File FPP-1996-027-2

Name: Cobblestone Ridges – Rana Road in the Ridges

COBBLESTONE RIDGES PHASE I RE-PHASING ROAD, UTILITIES AND LOT LINE CHANGES PLAN AND PLAT

COBBLESTONE
 SCALE: 1" = 100'
 SHEET NO. 1 OF 1
 EXHIBIT "A" WITH OFF-SITE PATH EXTENSION

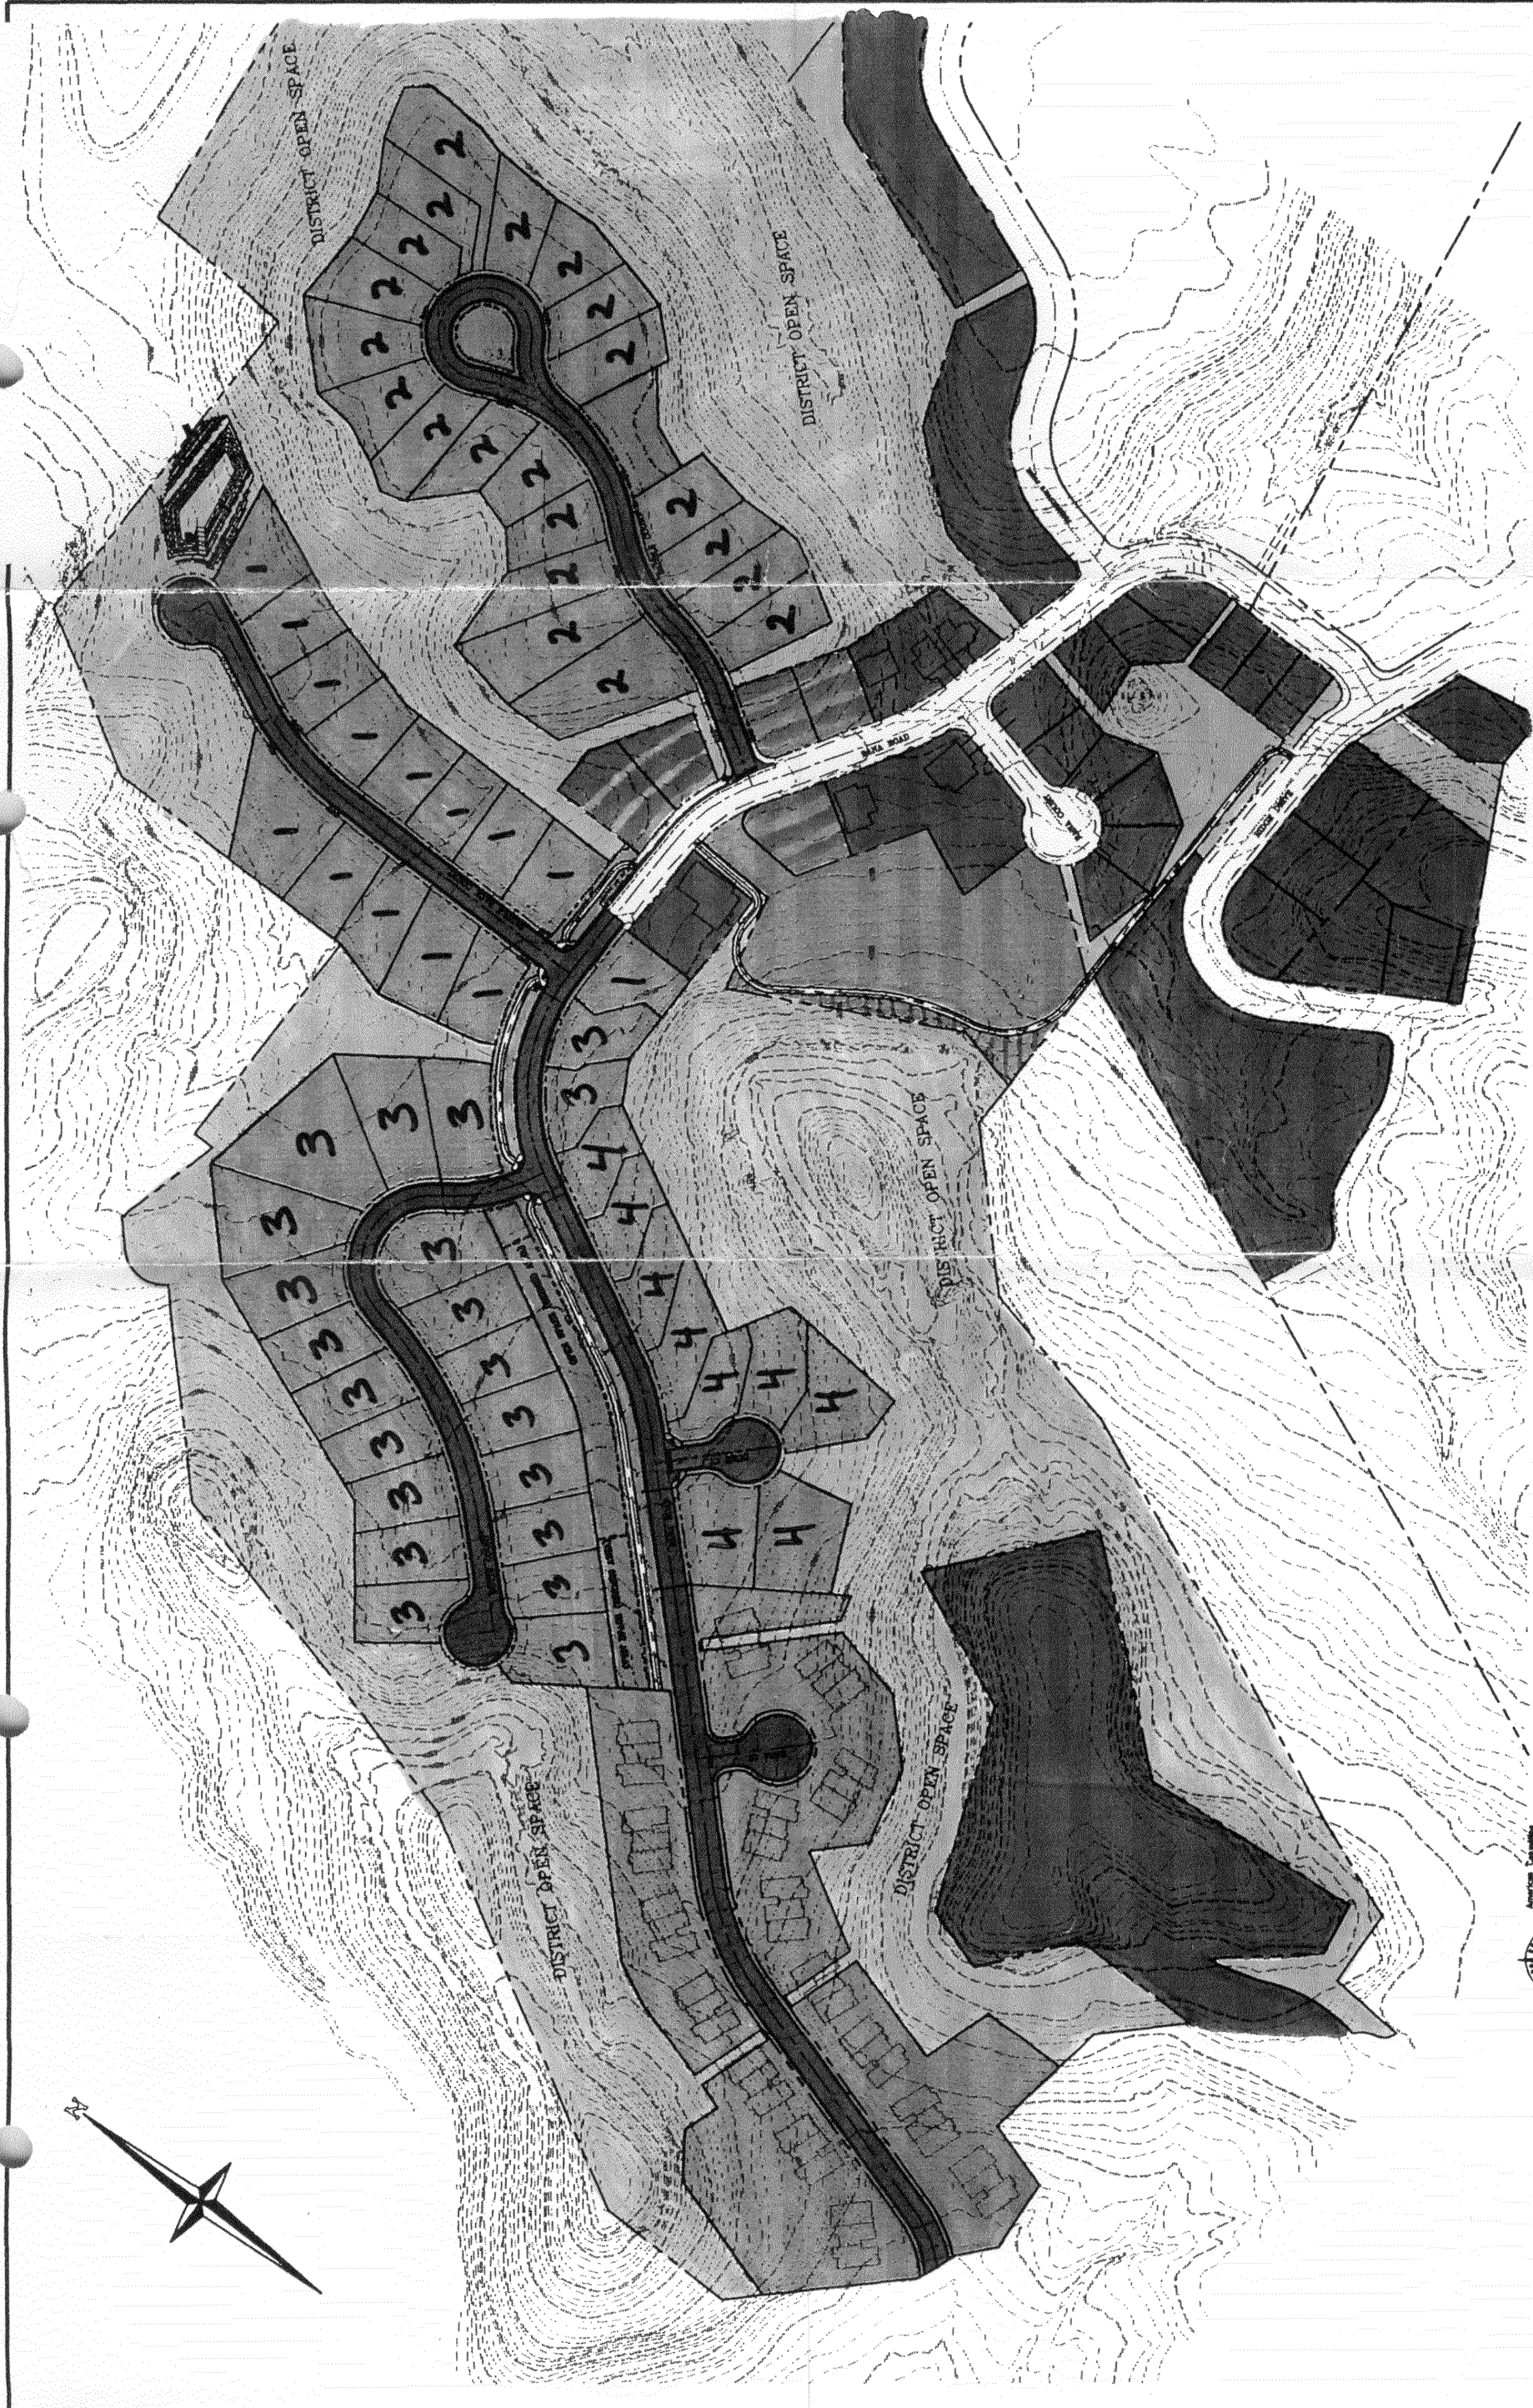
2. The earlier approval required that the off-site pathway system be designed and built by the developer of Cobblestone Ridges and paid for by the City. It was to have been built with filing 2. With the new phasing plan, it should be built with filing 1. The location and design should be coordinated with Public Works and Parks (see the attached proposed alignment).

- 2) Cobblestone agrees that the path should be built during the Phase 1 improvement period of Cobblestone Ridges, and agrees to do the same. Pursuant to the City's agreement to pay for the same, Cobblestone suggests that Thompson-Langford as the Applicants Representative be hired to: 1) create working drawings and specifications for the path, 2) establish a bid package for the path, 3) obtain bids from at least three approved and qualified contractors for the construction of the path, and 4) be hired to provide construction management for the path. Further, that the City will enter into and conclude negotiations with Thompson-Langford for the payment for same.

APPROVED FOR CONSTRUCTION	DATE	APPROVED AS CONSTRUCTED	DATE
CITY OF GRAND JUNCTION ENGINEERING		CITY OF GRAND JUNCTION ENGINEERING	
Cobblestone Ridges	SCALE: 1" = 50'	JOB NO: 0252-00	DATE: 9/2/96
COMPOSITE PLAN (PHASE 2)		SHEET NO: 1 OF 1

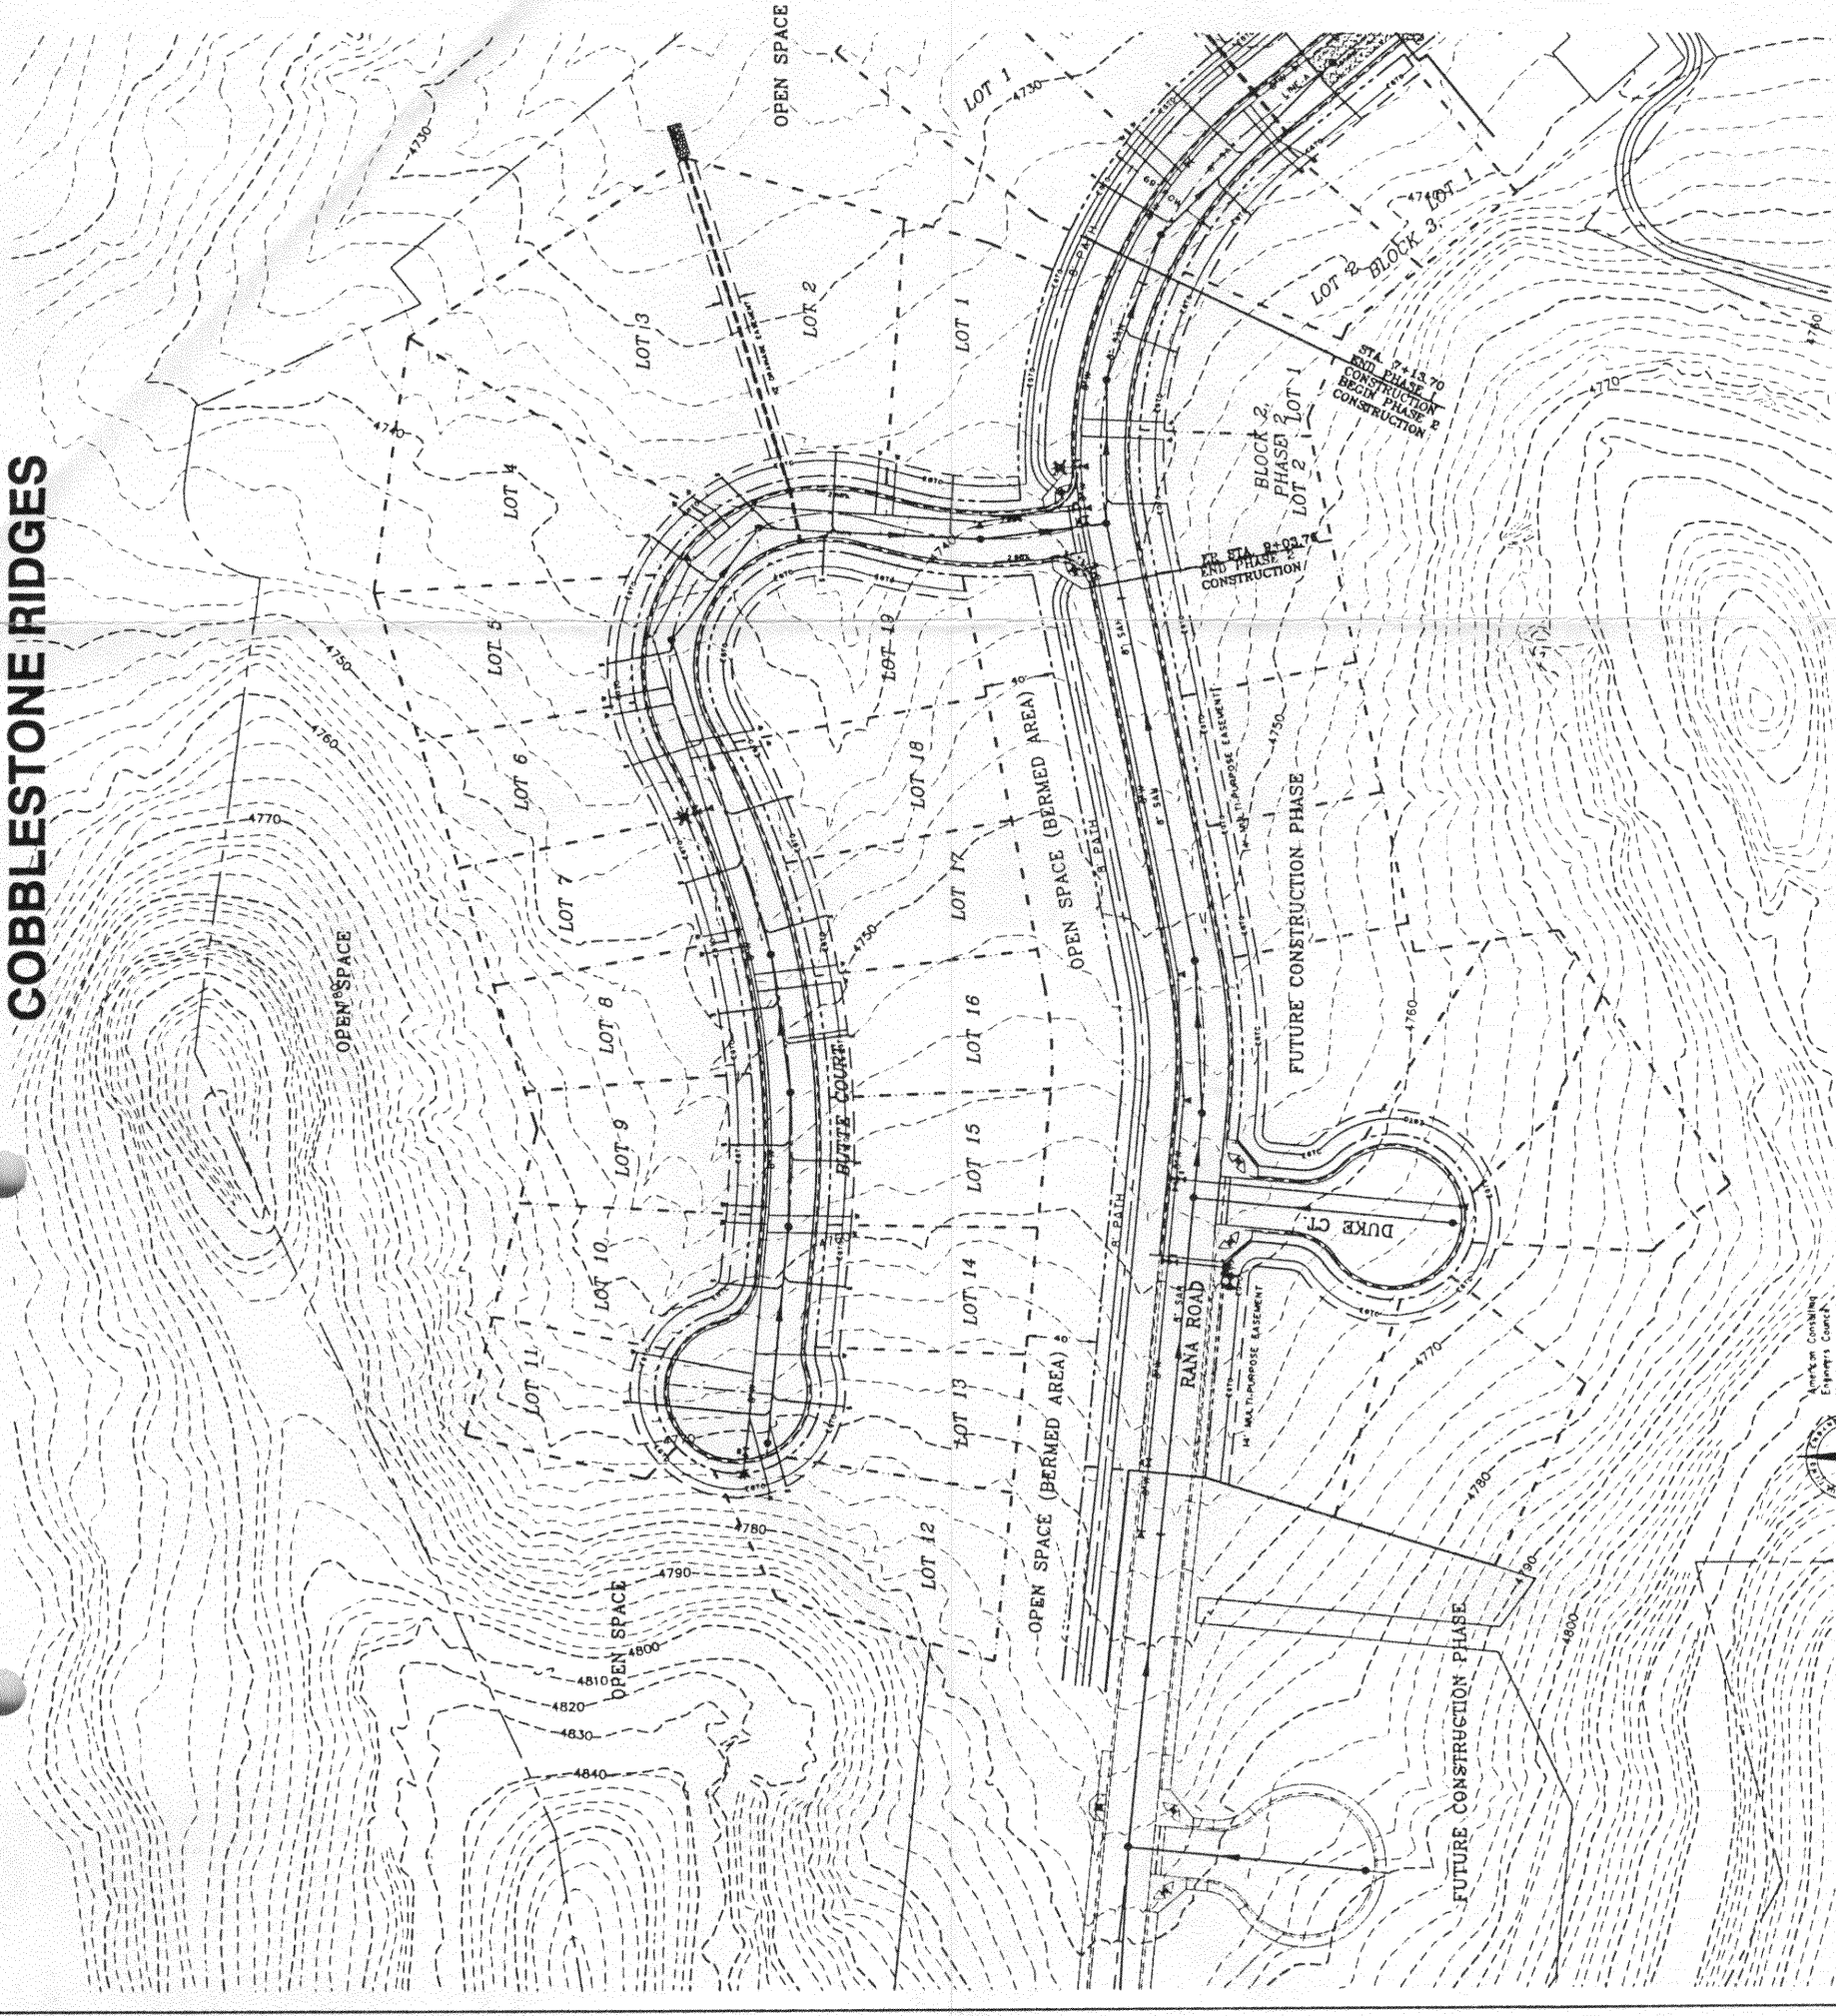
1. If irrigation is to be provided with this project, show irrigation lines on the utility composite.

2. A reminder from previous submittal review comments: The fire lines for this project must extend to the border of the project so that future extension and looping of the lines is possible. In future submittals, petitioner must show where the extension and looping will occur.

#2) We acknowledge the need for future looping. Currently, looping is impractical, and previous documentation has been provided demonstrating that the proposed development will provide the required 500 gpm at all hydrant locations.
